UNITED STATES PATENT AND TRADEMARK OFFICE

APPLICATION NO.	FILING DATE	FIRST NAMED INVENTOR	ATTORNEY DOCKET NO.	CONFIRMATION NO.
10/663,995	09/17/2003	Soon Jo Lee	9988.059.00-US	1979

Office Action Summary	Application No.	Applicant(s)	
	10/663,995	LEE ET AL.	
	Examiner	Art Unit	
	Stephen Gravini	3749

DETAILED ACTION

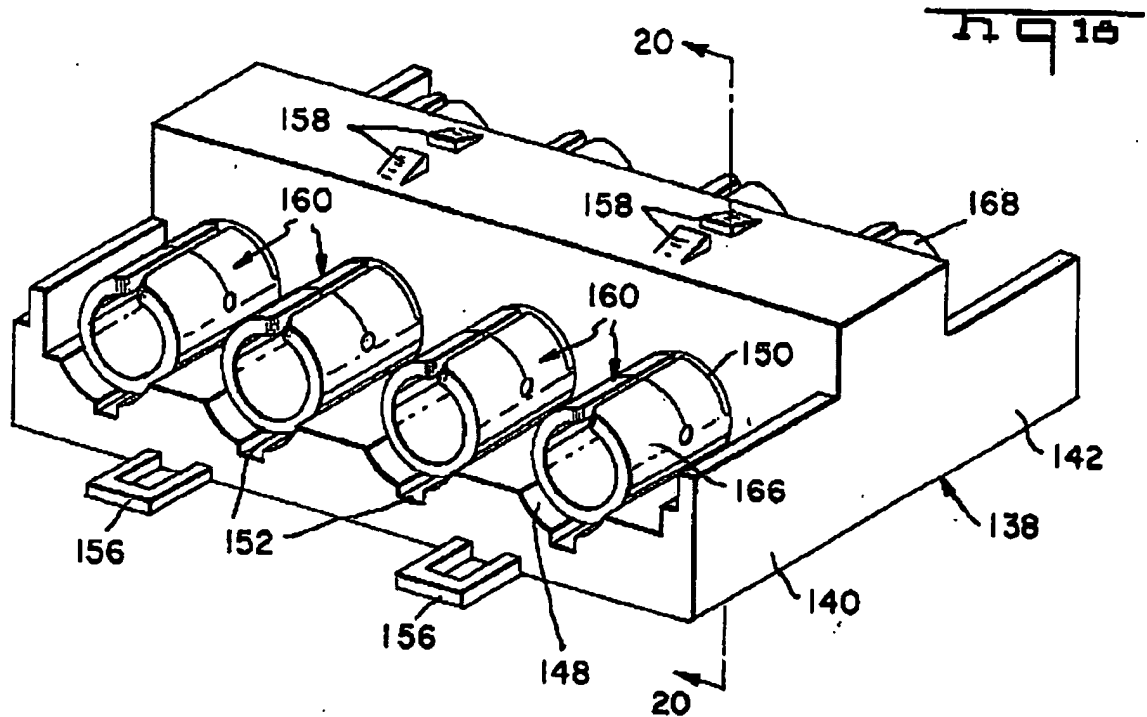
Claims 4-6 are rejected under 35 U.S.C. 102(b) as being anticipated by Hopkins et al. (US 4,010,996). Hopkins is considered to disclose the claimed invention comprising:

a terminal block **138** disposed within the laundry dryer control panel, the terminal block having a lower part **140** and an upper part **142**;

a wall extending from the terminal block lower part and the terminal block upper part (please see figure **18** reproduced below wherein the raised portion surrounding reference character **166** and above reference character **142** is considered to anticipate the claimed wall because both extend from a terminal upper and lower part respectively);

a first wire **32** or **170** extending out of the terminal block lower part; and

a second wire **170** or **32** extending out of the terminal block upper part wherein the wall extends from the terminal block such that the wall shields an exposed portion of the first wire and the second wire (please see column 7 lines 3-68 which is considered to disclose the claimed shielding feature). Hopkins is also considered to disclose the claimed feature wherein the wall covers a first connector coupling the terminal block lower part with a first power wire and a second connector coupling the terminal block upper part with a second power wire from a first side of the terminal block and a second

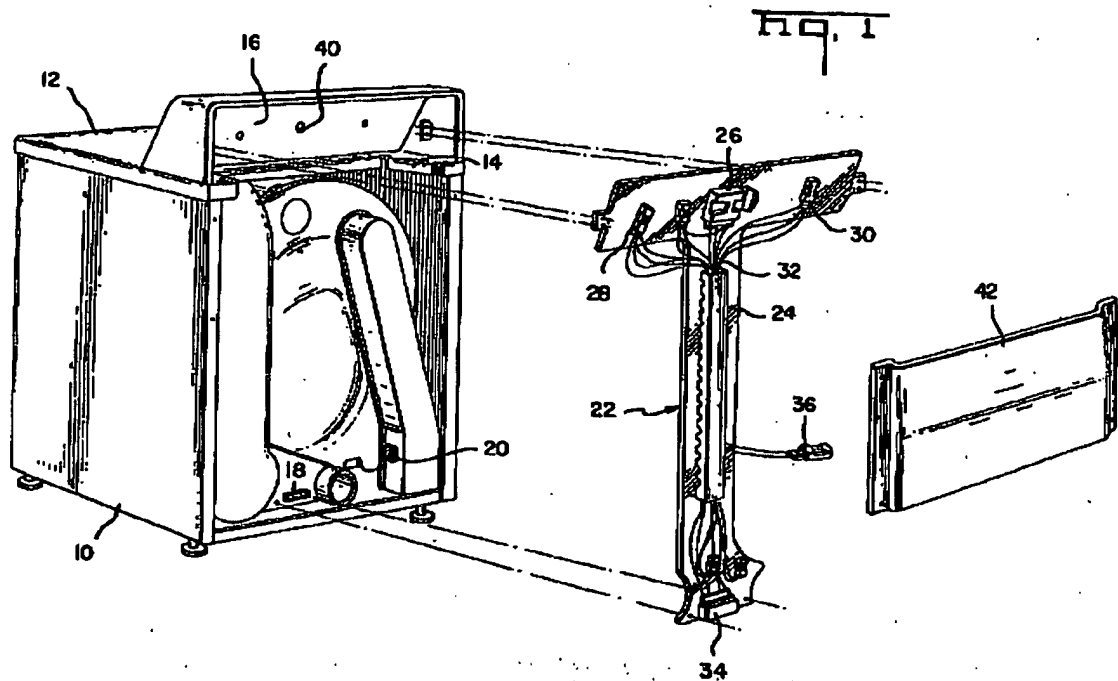
Claims 1 and 3 are rejected under 35 U.S.C. 103(a) as being unpatentable over McCormick (US 2,742,708). McCormick is considered to disclose the claimed invention comprising:

base **314** forming a floor;

a front cabinet **211** forming a front portion of the clothes dryer;

a side cabinet **218** forming a side portion of the clothes dryer;

a top cover **216** provided on a top surface of the front cabinet, the side cabinet and the back cover;

a control panel **217** provided on a rear portion of the top cover. McCormick is considered to disclose the claimed invention except for the claimed back cover forming a back side of the clothes dryer, terminal block provided on an inside of the control panel, a wall for shielding an exposed part of core wire extending from an upper front portion and lower front portion of the terminal block including a single body terminal block formation. Hopkins, another structure for a clothes dryer, is considered to disclose a back cover **42** in figure 1 (shown below),
